HDP – EMC Areas Review

During the February 1, 2018, NRC – Westinghouse publicly noticed teleconference the NRC and Westinghouse reviewed the 5 agenda items discussions/proposed path forward Westinghouse response to the January 24, 2018 agenda items identified at that time. During the February 1, 2018, teleconference a 6th agenda item was preliminarily discussed.

6. How many LSA survey units contain an elevated area? How many survey units contained a shared EMC/survey unit boundary? The EMC areas are of concern as in the future they may be excavated and brought to the surface. The EMC areas that have a shared boundary with a survey unit appear that the EMC area is also in an adjacent survey unit. The concern would be a dose consequence for the adjacent survey unit.

EMC Investigation Area within LSA 10-04

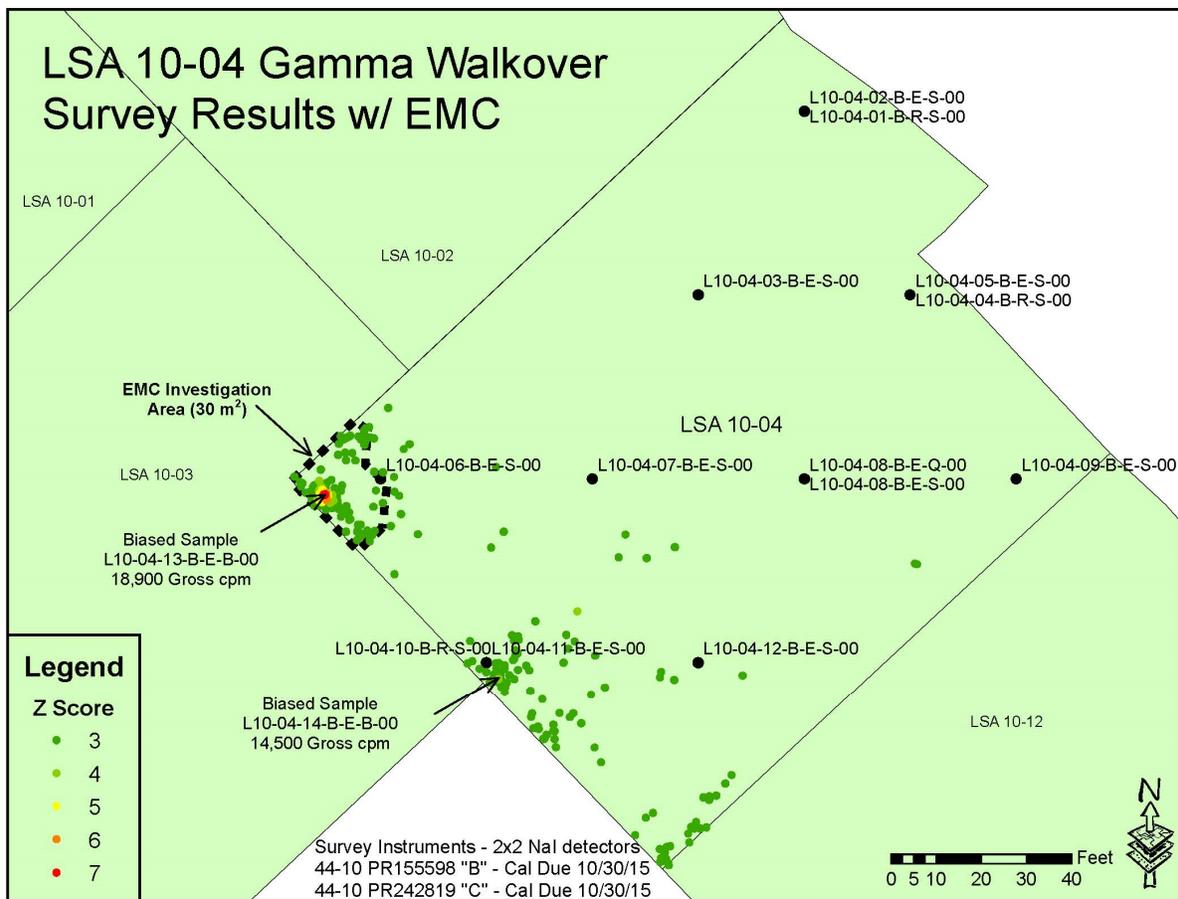
The size of the associated elevated area surrounding this biased location was determined by using the nearest "clean" systematic location and the boundary edges of the SU itself to define a polygonal area of 30 m² as calculated by GIS software. The shape of the EMC area was designed so as to include the elevated GWS measurements proximal to the elevated biased sample.

EMC Investigation Area within LSA 10-07

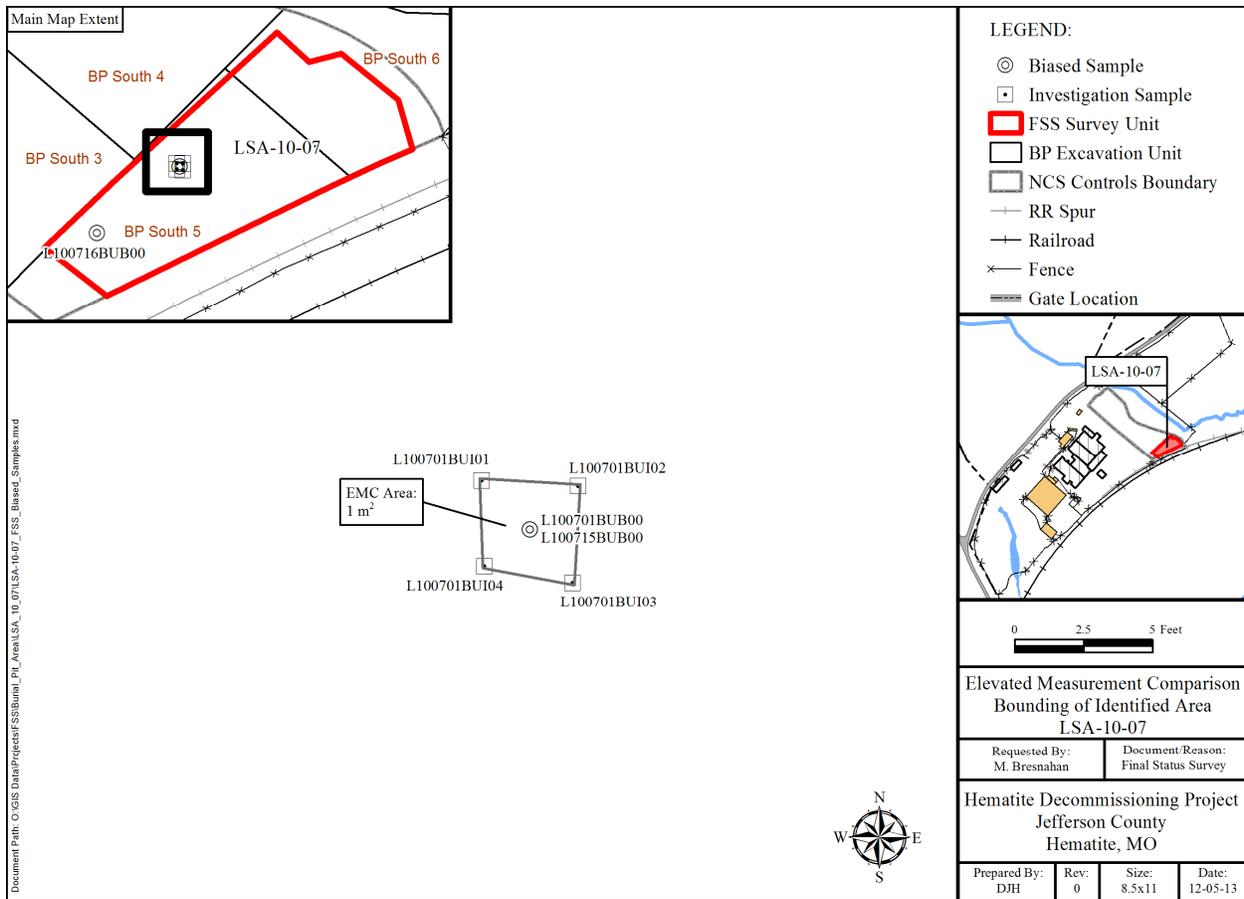
The size of the associated elevated area surrounding this biased location was determined by “bounding” where four investigation samples were collected in a 1 meter square grid surrounding the sample. As all four investigation samples had SOF results less than 1.0, the area was determined not to exceed 1 m². Furthermore, subsequent scanning of the area indicated that the count rates had greatly decreased since the first biased sample was collected. An additional sample (L10-07-15-B-U-B-00) was collected at the exact sample location as the elevated sample, but at a depth of 6 to 12 inches bgs, (where the original sample was collected at 0 to 6 inches bgs). This sample also had a result that was less than a Uniform SOF of 1.0. These sample results indicate a very small area of elevated contamination that was contained within the elevated biased sample (e.g. deconning by sampling), and was no longer present in the SU. Nevertheless, an EMC was performed to demonstrate that the results of the elevated biased sample still meet the release criteria within the LSA.
